RIXS CREEK MINE - CONTINUATION OF MINING PROJECT

Response to Submissions

SSD_6300 Rix's Creek Mine Continuation Project

20-Oct-2016

Figure 5-6 Predicted 24-hour average PM₁₀ concentrations for Receptor 45 in Year 2017 and 2020

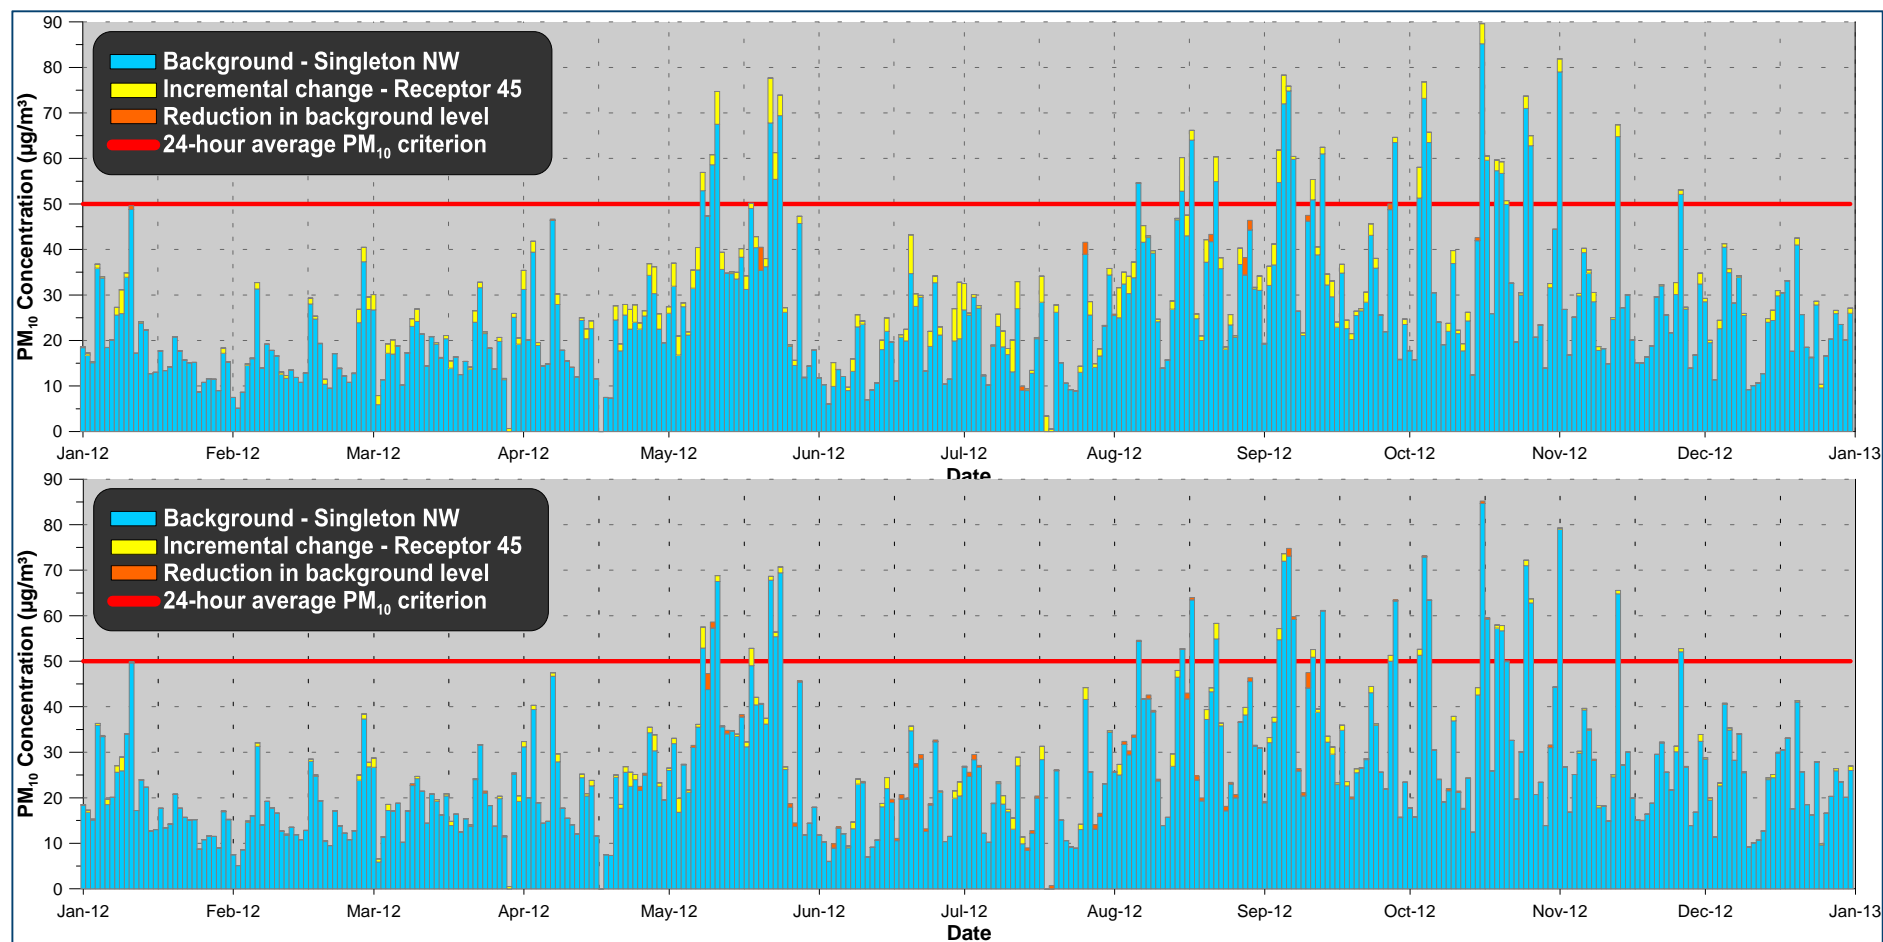
Time series plots of the 24-hour average PM₁₀ concentrations are presented in **Figure 5-6** and **Figure 5-7**.

The time-series plots presented in **Figure 5-6** and **Figure 5-7** indicate that **Table 5-3** is not a good indicator of potential impact. The plots are included to show how a general decline in overall impacts occurs over time (noting that Year 2023 is modelled at higher activity rates than are now proposed to occur).

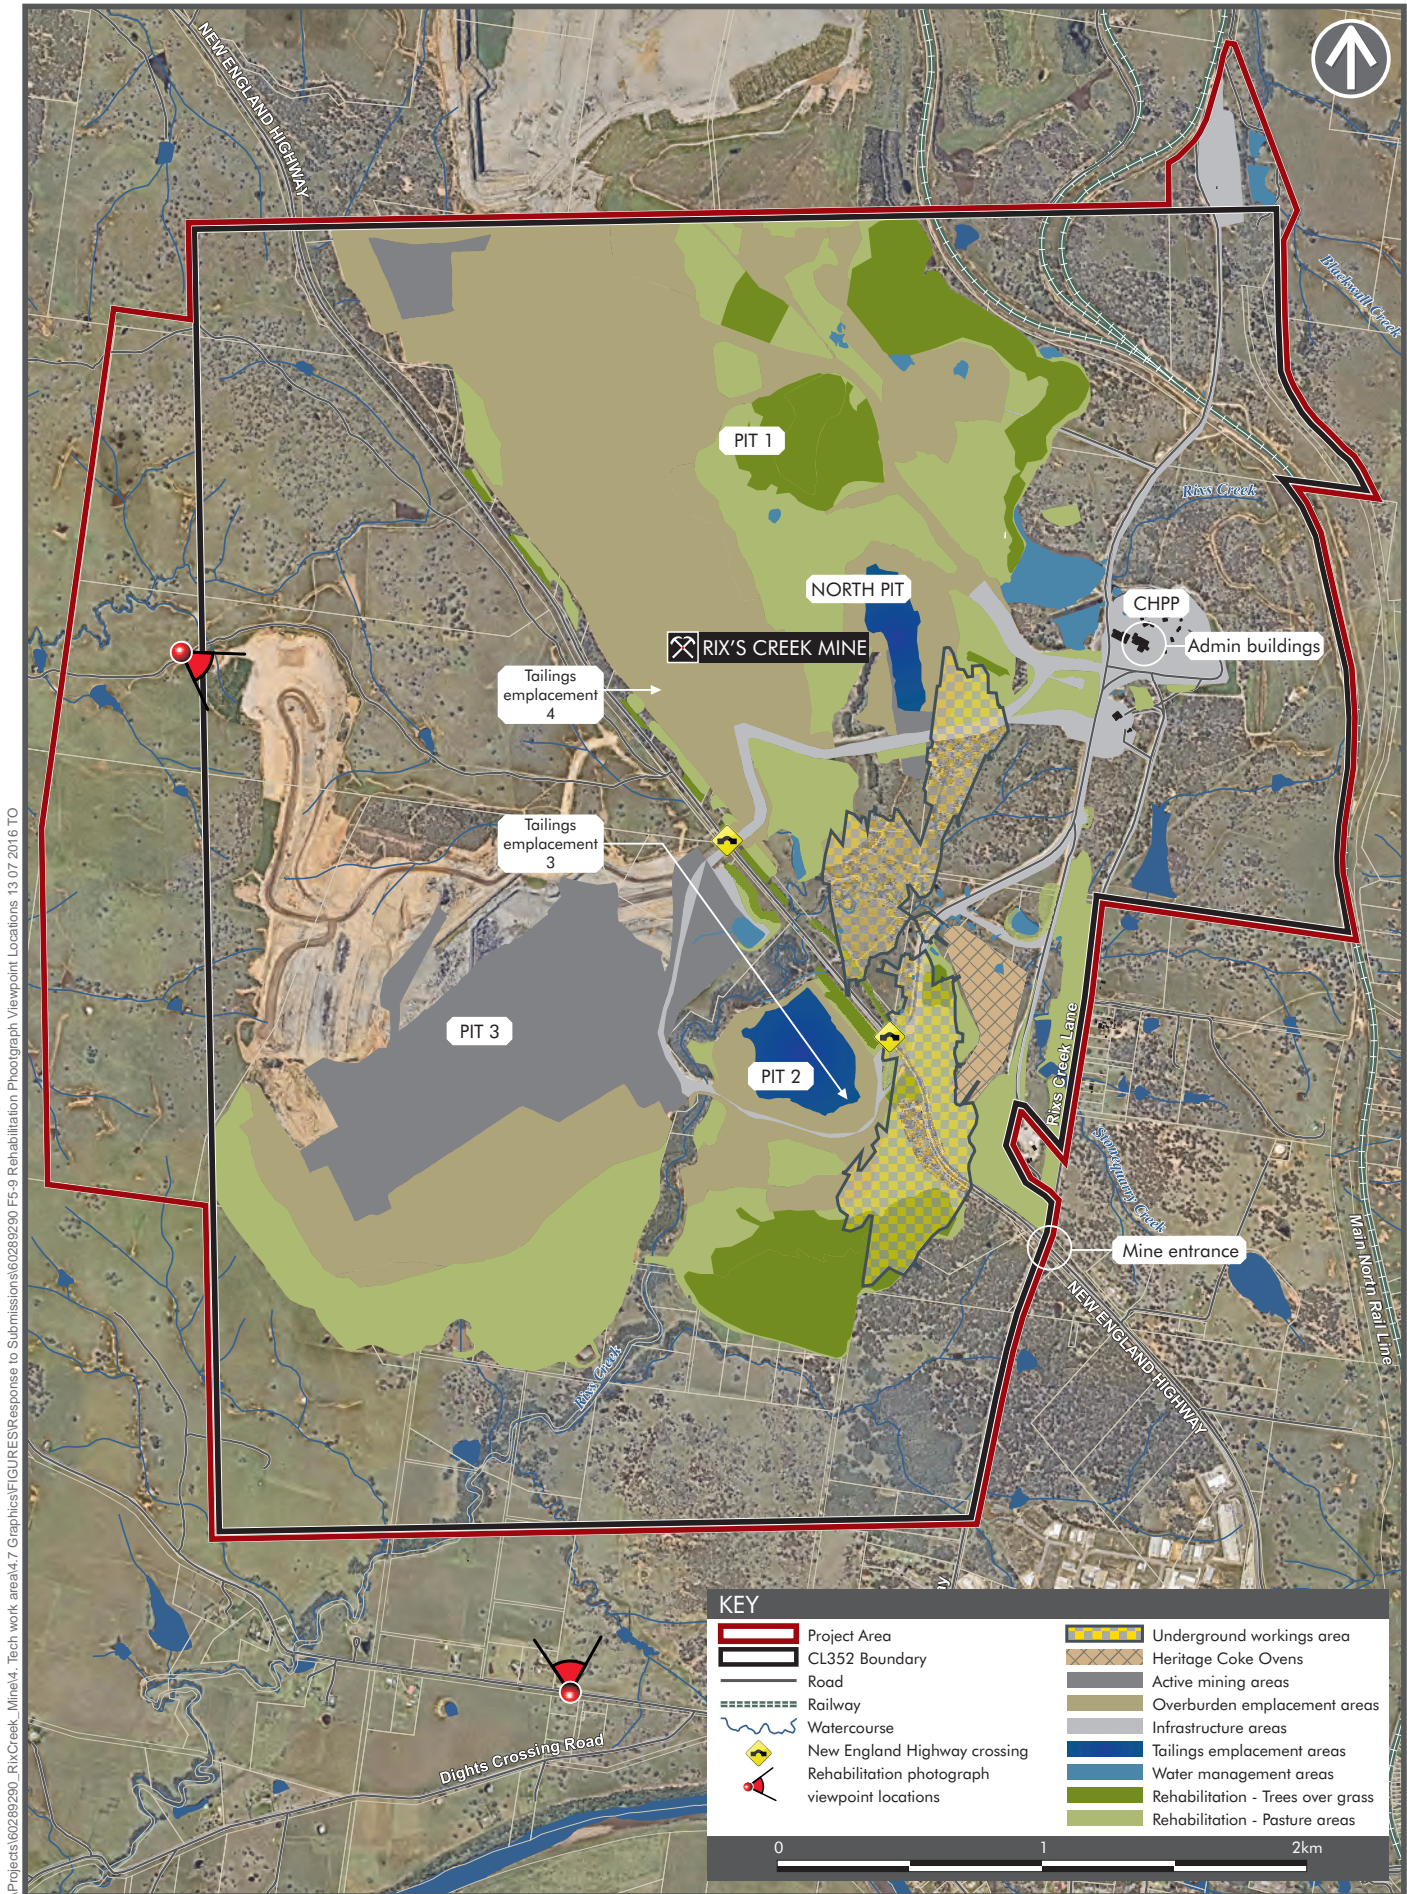
In order to provide a better indication of the existing nature of the Mines rehabilitation works and how they have been progressively designed and undertaken to be consistent with natural landforms a number of plates have been prepared to illustrate current Mine rehabilitation works. Plates **Plate 5-1** to **Plate 5-5** have been prepared to show examples of existing Mine rehabilitation areas adjoining natural landform and the progression of rehabilitation in these key areas.

The viewpoint locations from which these images were taken are detailed on **Figure 5-9**. While the chosen viewpoints are not from New England Highway locations it should be noted that these are representative onsite examples of the sites progressive rehabilitation. Generally speaking similar views do not exist from the New England Highway due to the progression of mining and vegetative screening.
